Product Change Notification - KSRA-20UFUA549

CCB 3368.001 Final Notice: Qualification of MMT as an additional assembly site for selected Atmel products of 35.4K, 35.5K and 19.6K available in 32L VQFN (5x5x0.9mm) package

Qualification of MMT as an additional assembly site for selected Atmel products available in 32L VQFN (5x5x0.9mm) package

Title: 32L VQFN 5x5mm, pitch 0.5 mm, exposed pad 3.1x3.1 mm
 PACKAGE OUTLINE DRAWING

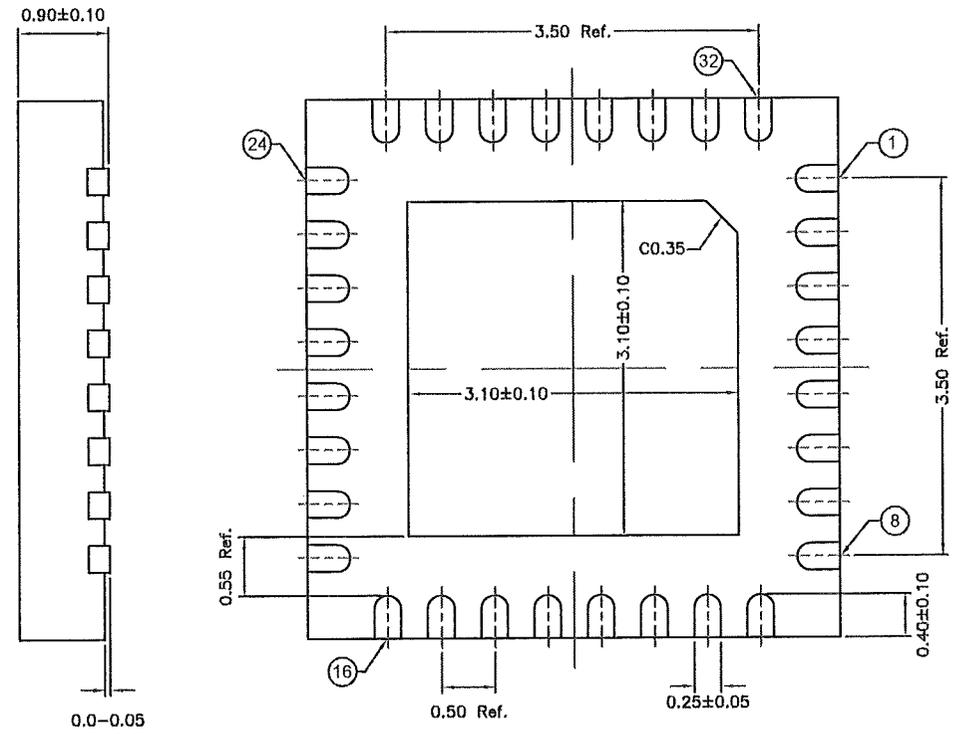
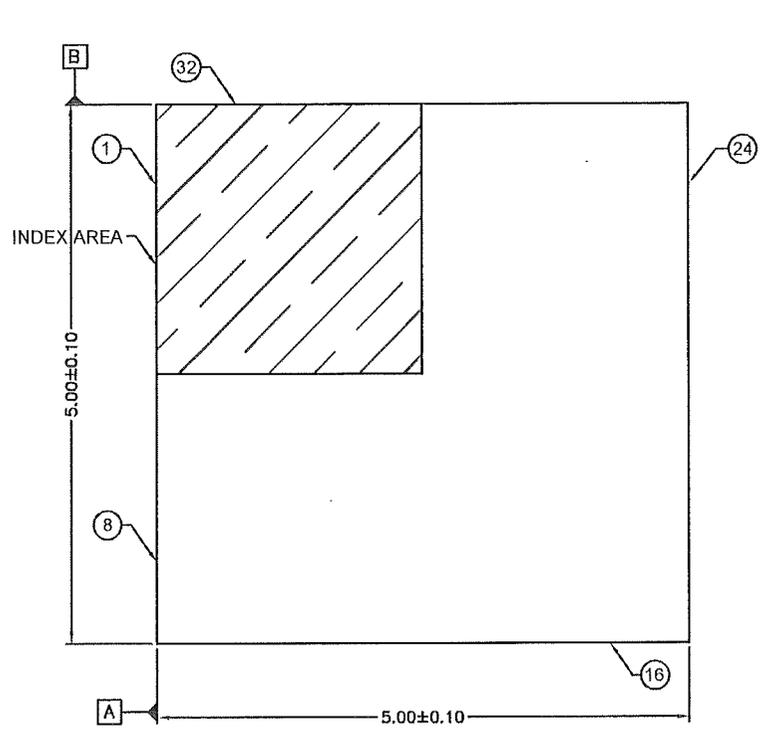
Assembled at ANAC assembly site with punched as singulation method using 8290 die attach material and Assembled at MMT assembly site with sawn as singulation method using 3280 die attach material

Yes; Package outline drawing- change from punch version to saw singulated

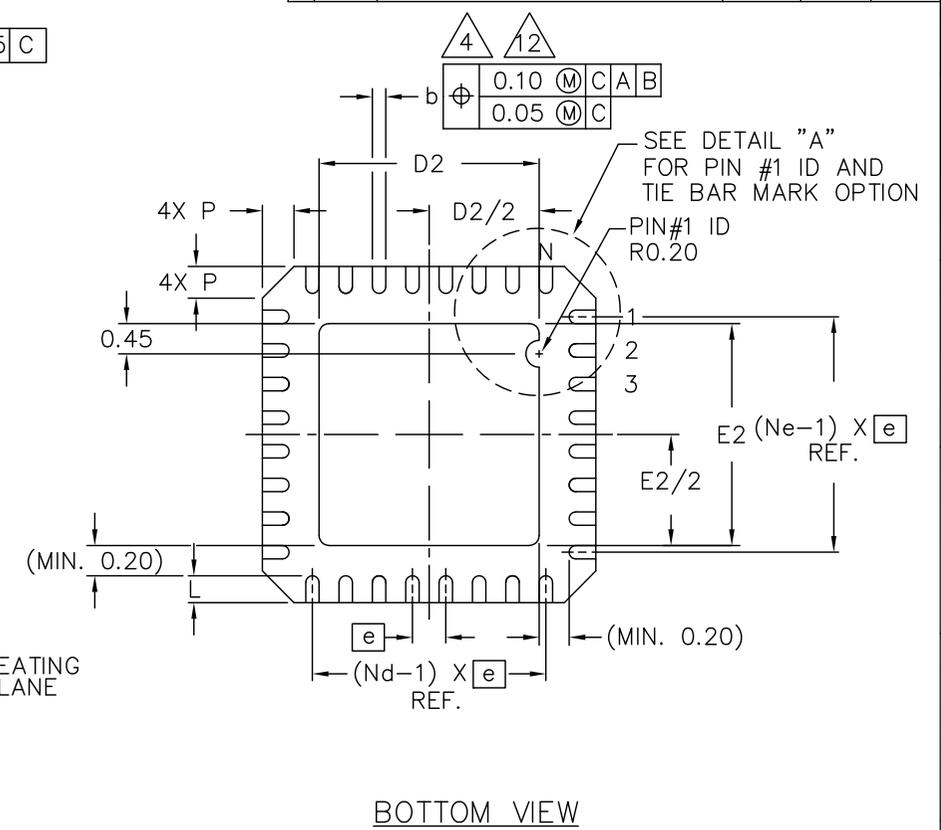
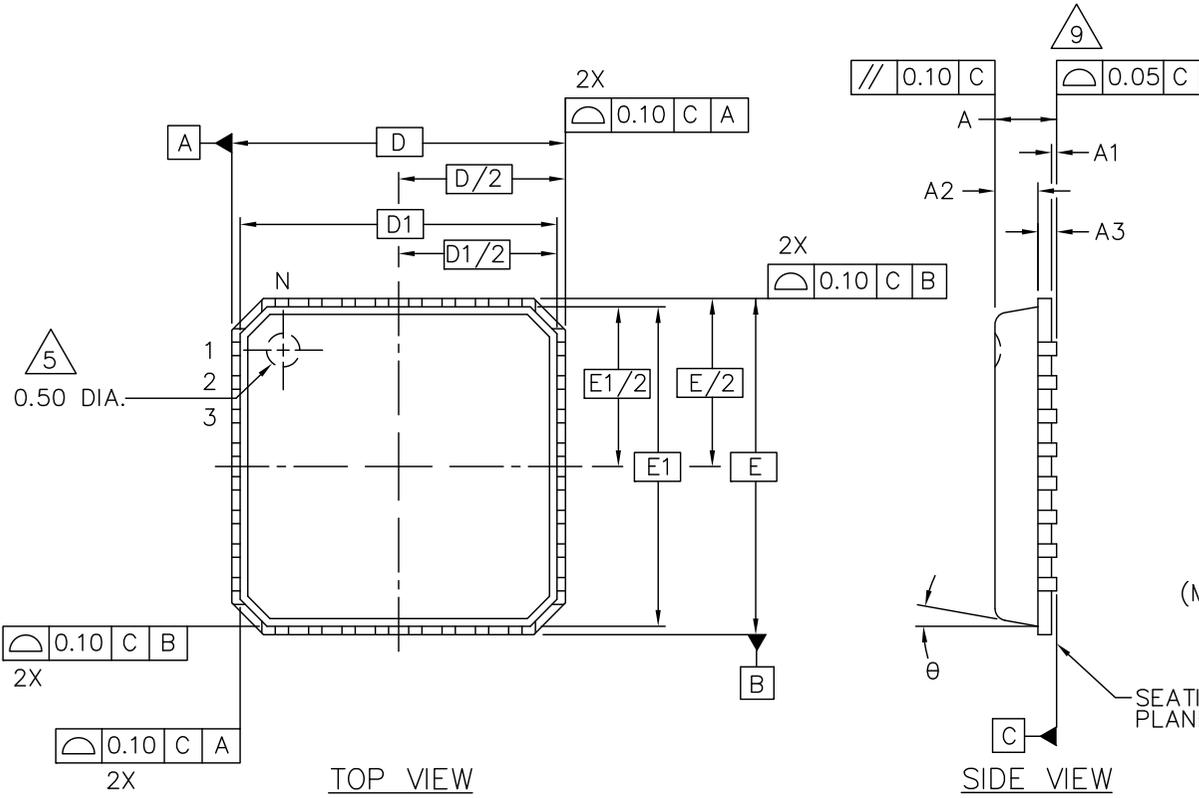
Assembled at ANAC assembly site with punched as singulation method using 8290 die attach material
